MARINE ADVISORY BOARD 1201 N.E. 5th Avenue Pompano Beach, Florida 33060 Memo # 21-02

RE: MAB review and evaluation of Petition to the Zoning Board of Appeals dated 11 September 2020 Applicant: 2406 Bay Drive Revocable Trust

MAB Review & Recommendations Variance Request: 2406 Bay Drive Revocable Trust Date: 30 March 2021 Page 2

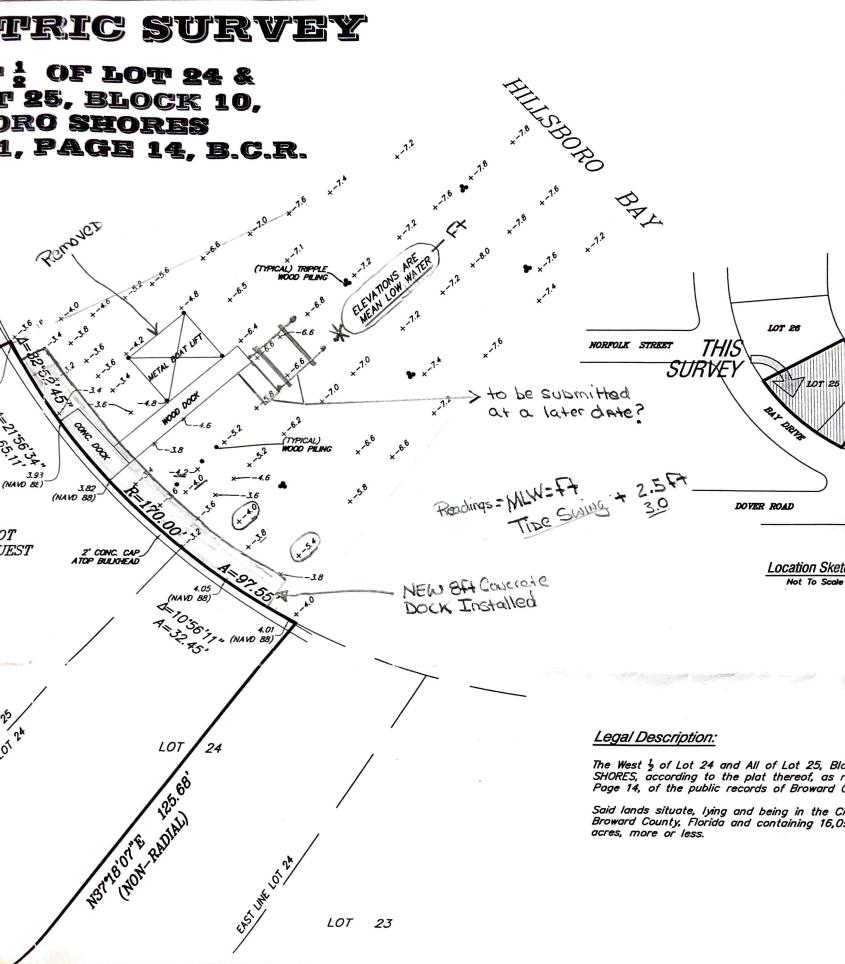
If granted, a vessel cannot be moored at the proposed finger pier. A variance for perpendicular docking cannot be recommended or granted by ZAB under 91.10(C)(2)(a) which states:

As a result, it is anticipated the petitioner will come back to request a variance for an addition structure at the end of the pier (ancillary dock) and a boat lift that would extend 62-feet from the property line. Otherwise, the 47-foot finger pier would serve no purpose.
